P03:
Changes made to previously approved proposal

Previous NMA Proposal submitted under application ref. 2020/1990/P & Listed Building Consent ref. 2020/1992/L

DRAWING TITLE	GA PLAN PROPOSED GROUND FLOOR LEVEL PLAN
DRAWING NO.	CTH-PUR-MP-G0-DR-A-92001
REVISION	P03
SIZE & SCALE	A1L 1:200 @A1
DRAWING STATUS	S4 - Planning

CLIENT	Lendlease
PROJECT	Camden Town Hall
JOB NUMBER	238664

I 92001 PROPOSED GROUND FLOOR LEVEL PLAN 1:200 @ A1

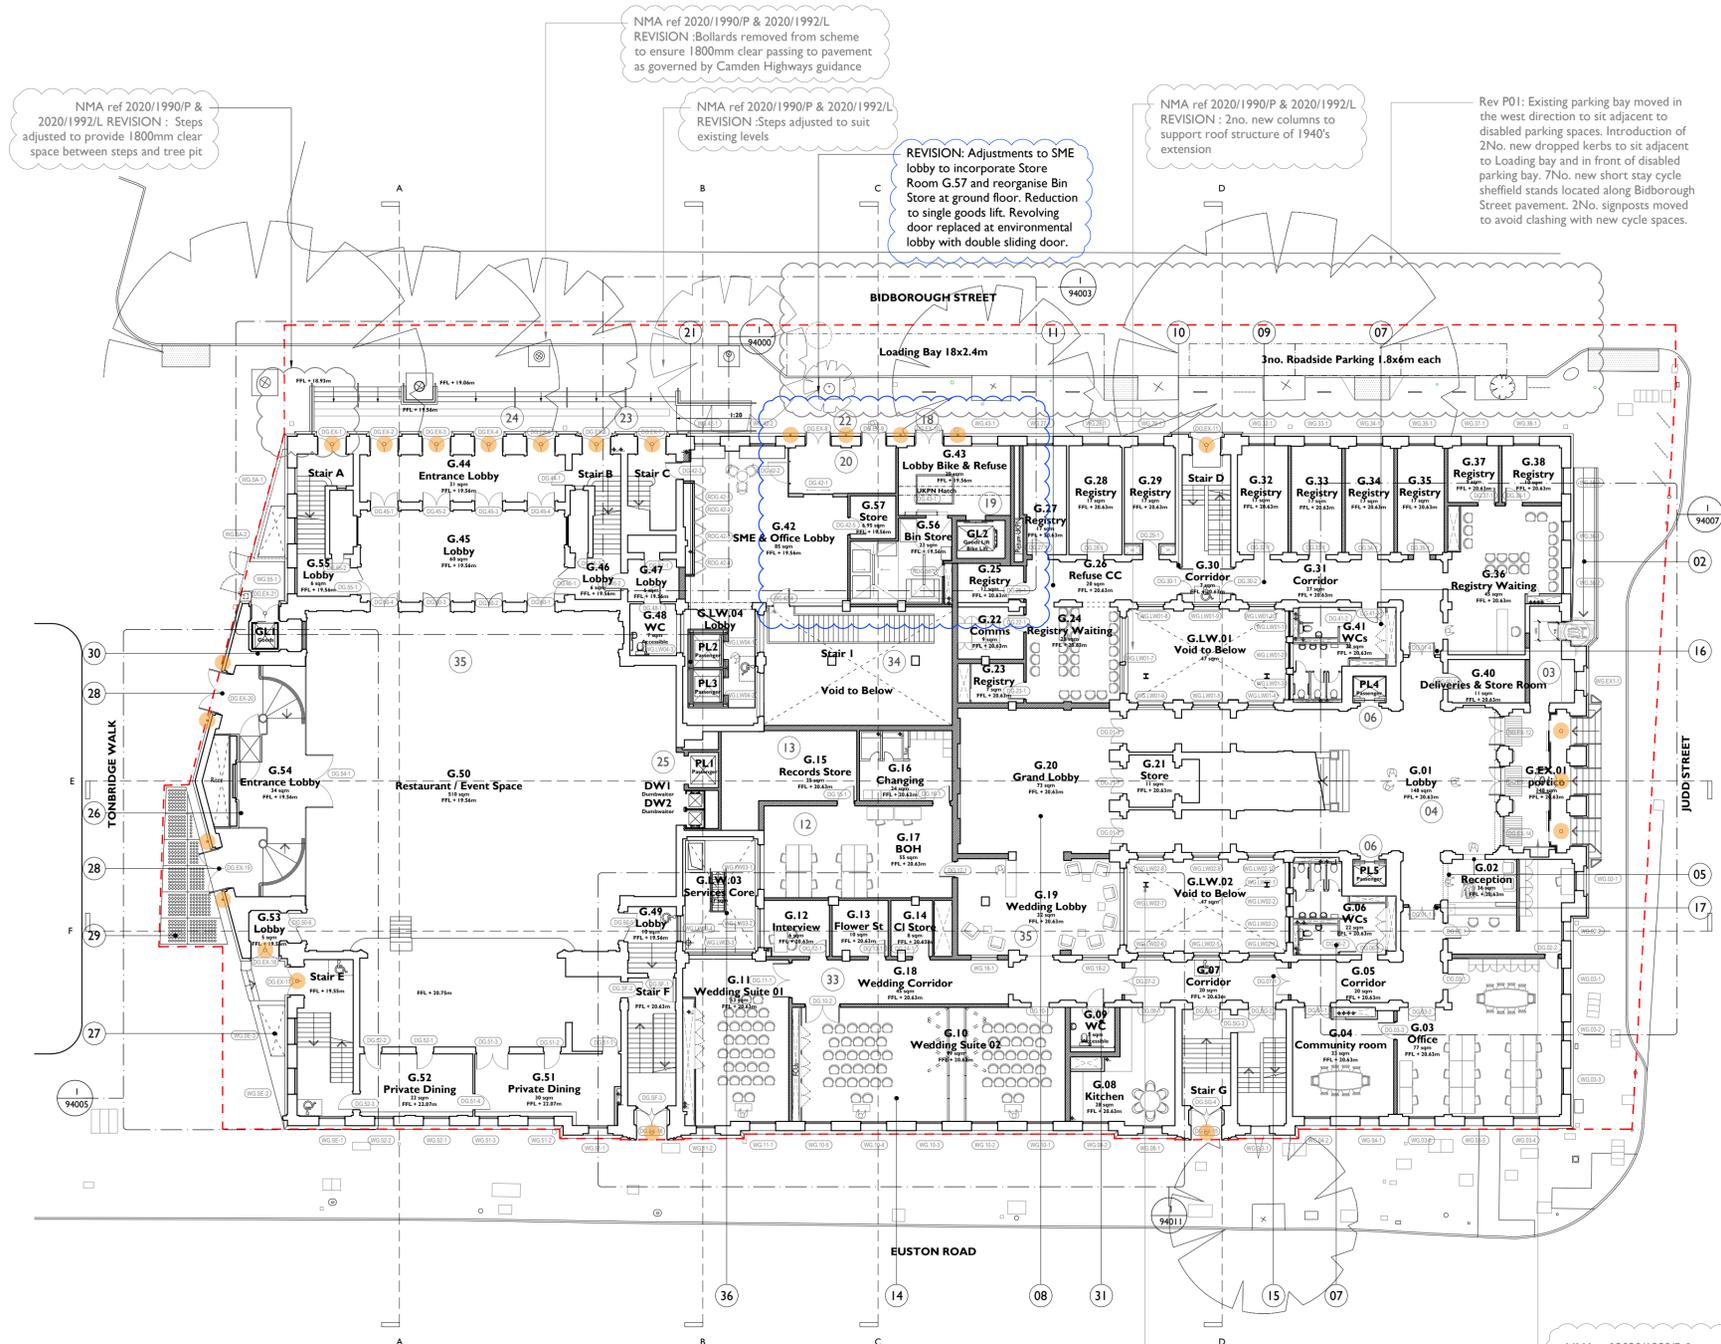
- Existing detrimental (non-original) glass draft lobby within Judd Street porticoed entrance removed. Original stepped arrangement demolished and rebuilt to match existing following condition survey and existing fabric to portico made good following removal of glass lobby. Existing security shutters to the three portico openings to be removed and replaced with new and fitted with a mechanical lock to the bottom of shutter. New aluminium profile glazed entrance lobby to replace existing and maintain thermal comfort. New digital wayfinding screens to be mounted on stone columns either side of central door opening.

- Existing finishes to ramp removed and upstand rebuilt to Approved Document M standards for accessibility with new waterproofing. Full replacement of stone cladding and new black metal handrail fixed to upstand. Entrance door removed to provide a clear opening into portico entrance. New security shutters to be fitted internally.

- Lobby linking ramp to portico entrance will be widened by removing obstructing partitions. Stone floor to be inserted to match the existing portico finishes. Walls and ceiling to be redecorated and made good.

- Existing RH door to be retained and reinstated into LH northerly door entrance and to be held shut. Existing left hand door to be retained and reinstated into right hand door entrance and upgraded to automatic push release for accessible entrance. Central door to be retained. Air curtains incased in bronze boxing to be inserted over 3No. entrance doors.

- 2No. new openings created in existing fabric to form entrances into proposed Reception area. Opening connecting to lobby to be formed within existing recessed arched reveal. Opening connecting to corridor to be full width. Security room to meet LBC requirements integrated within reception.

- Existing lift shafts retained, passenger lift cars replaced and upgraded
- New WCs inserted within existing location. 1 No. fully compliant accessible WC to be integrated.

- Non-original/detrimental fabric removed to create secondary grand lobby. New interior finishes to walls and floors proposed. Decorative illuminated ceiling proposed.

- Original corridor form retained - non-original walls removed, and new registry rooms created.
- Existing doors upgraded to create a fire lobby and refuge point.

- Historic corridor form reinstated, and original fabric repaired. Opening created in existing fabric into registry waiting area.
- New stud walls inserted to create back of house spaces.

- New record store introduced, original vault door retained and relocated.
- Detrimental partitions removed and new wedding suites inserted. New pair of sliding / folding partitions introduced to allow rooms to be divided into 2No. wedding suites - to achieve 45 Rw acoustic rating.

- Corridor form retained. New fire doors inserted to match existing to create fire lobby and refuge point.
- Existing door upgraded to provide access control

- New double doors inserted to match existing.
- Existing external door opening utilised for entrance into new bin and refuse lobby
- New Goods and Bike lifts inserted. Existing timber doors removed, and new aluminium double door set inserted. Floor level lowered to achieve level access from street level

- Access hatch created in floor for access to UKPN substation at basement level. Lifting beam introduced at high level above access hatch.
- 2 new openings created into new office entrance lobby. Floor level lowered to achieve level access from Bidborough street. Proposed draft lobby with sliding doors inserted internally.

- Two new passenger lifts servicing all floors inserted into South East Lightwell. Windows upgraded to 60min fire rating.
- Paving level altered to allow level access into Office/ SME lobby. Road levels and drainage to be altered accordingly.

- New stepped and ramped arrangement to Camden Centre introduced to allow for level access across all entrance/exit points. Existing motorcycle parking zone relocated to Tonbridge Road and paving line extended to allow for clear access around tree existing tree pits. All existing tree positions to be retained

- 4No. entrance doors to Camden Centre to be retained and repaired. 3No. existing doors to stair cores A, B & C to be retained and repaired.
- New passenger lift and 2x dumbwaiters servicing Basement, Ground and 1st floor gallery inserted.

- New lobby inserted for form new entrance to Tonbridge Walk. Ground level lowered to create level access to Tonbridge Walk. Stepped access and platform lift inserted. Service riser introduced. Existing historic panelling retained and brought forward to sit in front of new riser

- 1960's extension to corner of Tonbridge Walk/Euston Road to be demolished. External area to be rebuilt to mirror southerly end of Tonbridge Walk. Stone plinth inserted with metal railings and gate forming a tertiary exit point from the Camden Centre. Original door and window positions retained and repaired following removal of 1960s insertion.

- 2No. new openings created in Tonbridge Walk façade and new double door sets inserted to create an entrance into Camden Centre.
- Existing Lightwell covered with luxcrete panels to allow smoke ventilation from basement below. Works to be undertaken as part of Crosstree Annex development.

- Goods/refuse lift inserted serving ground floor and basement. Existing stepped and raised platform arrangement removed so that there is a level approach from street level to goods lift. New door inserted into larger opening to match existing profiles.

- Existing door to new accessible WC to be altered to have removable steps to allow for outward swing in an emergency.
- Detrimental fabric removed and new wedding waiting lobby introduced with new internal finishes.

- New wedding corridor formed with new internal finishes.
- Area of ground floor removed to create void to basement below. New steel stair inserted to access SME space from entrance lobby.

- Existing fabric within Camden Centre retained and repaired.
- Service gantry and staircase to be inserted in lightwell for access to plant at each level.
